# Work Order ID 101016

Item ID: D350-689-023  
 Revision ID:  
 Item Name: Energy Attenuating Floor Provisions  
 Start Date: 4/30/13 Start Qty: 1.00  
 Required Date: 4/30/13 Req'd Qty: 1.00  
 Reference:

# DART SERVICE INSTRUCTION

## TO AMEND INSTALLATION INSTRUCTIONS IIN-D350-689 REV. B AND INSTRUCTIONS FOR CONTINUED AIRWORTHINESS ICA-D350-689 REV. 1

**FIGURE 1: UPDATES TO CROSS SECTIONS F-F AND M-M**  
 With reference to Figures 5 and 7 of IIN-D350-689  
 (Figures 25-5 and 25-7 of ICA-D350-689)

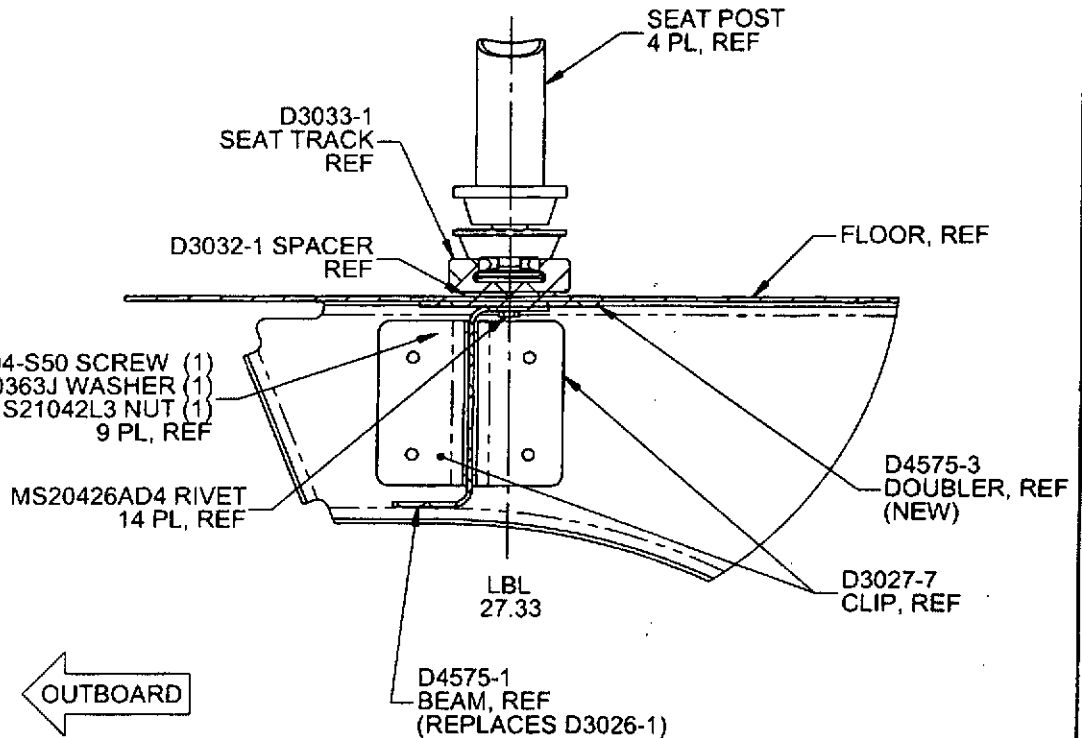
If there is an existing stringer at LBL 27.33, it will need to be removed from that location. Locate D4575-1 Beam, D4575-3 Doubler, and D3032-1 Spacer as shown in Figure 1 of this Service Instruction. Transfer drill existing holes from the aircraft floor to the D4575-1 Beam, D4575-3 Doubler, and D3032-1 Spacer. Ensure 1.0" to 1.5" rivet pitch and add additional holes if required. If there is no existing stringer, locate D4575-1 Beam, D4575-3 Doubler, and D3032-1 Spacer as shown in Figure 1 of this Service Instruction and drill Ø0.128" holes on a 1.0" to 1.5" pitch.

If there is an existing stringer at LBL 27.33, it will need to be removed from that location. Locate D4575-1 Beam and D4575-3 Doubler as shown in Figure 2 of this Service Instruction. Transfer drill existing holes from the aircraft floor to the D4575-1 Beam and D4575-3 Doubler. Ensure 1.0" to 1.5" rivet pitch and add additional holes if required. If there is no existing stringer, locate D4575-1 Beam and D4575-3 Doubler as shown in Figure 1 of this Service Instruction and drill Ø0.128" holes on a 1.0" to 1.5" pitch.

**FIGURE 3: RELIEFS ON D4575-1/-3**  
(ONLY D4575-1/-3 SHOWN FOR CLARITY)  
VIEW LOOKING INBOARD

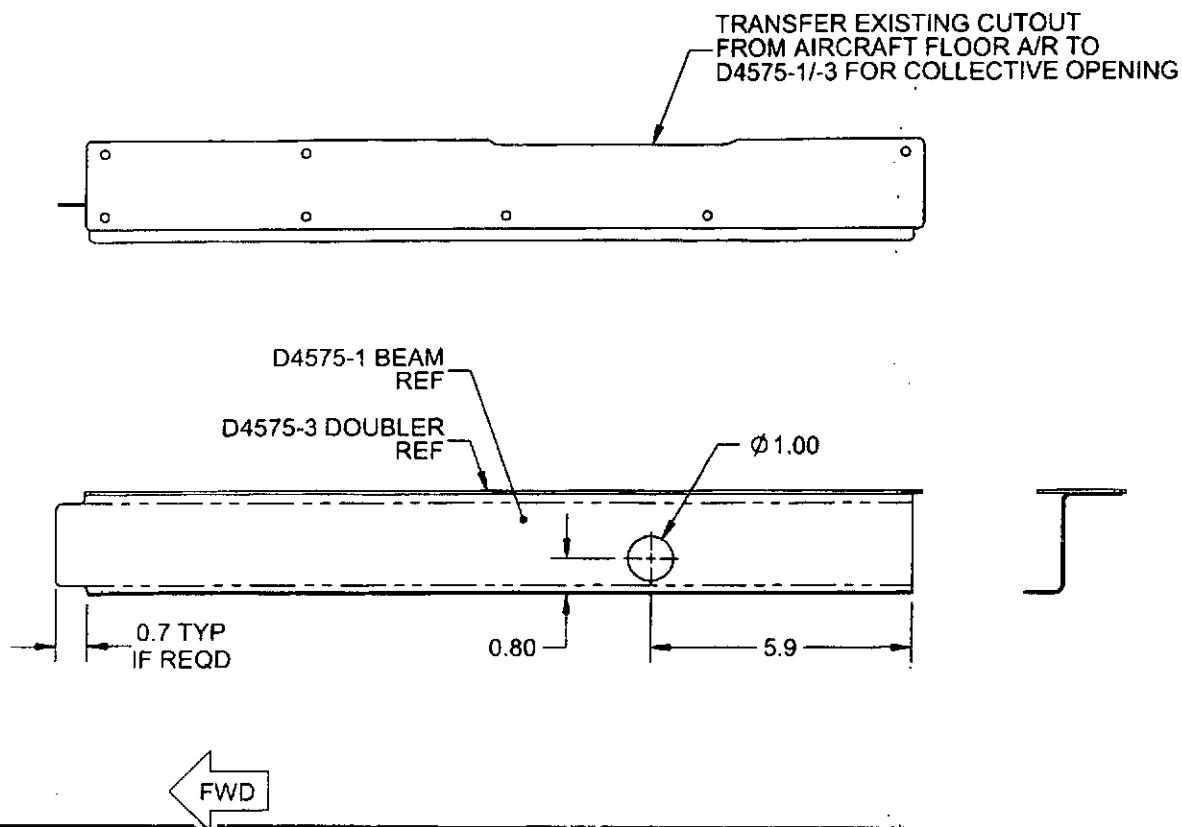
**Note:** Drill a Ø1.00" (Ø25.4 mm) hole in the D4575-1 Beam to clear extension tube of collective and cutout as required for clearance of collective opening and fwd bulkhead as shown in Figure 3 of this Service Instruction.

**Note:** Drill a Ø1.00" (Ø25.4 mm) hole in the D4575-1 Beam to clear extension tube of collective and cutout as required for clearance of collective opening and fwd bulkhead as shown in Figure 3 of this Service Instruction.
